## **Access Compliance Report Public Rights-of-Way** (Island Curb Cuts)

Main Street: REMOUNT RD **Cross Street: N/A** Location: Ε Intersection ID: 10035790 Curb Cut Type: MedianRefuge2 Initial Pass/Fail: Fail **Overall Compliance: No ADA ID: 9CE4B74C334F** Severity Score: 1.25

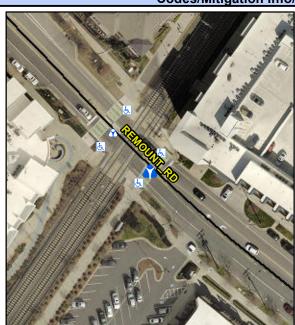
Remove & Replace Entire Refuge.
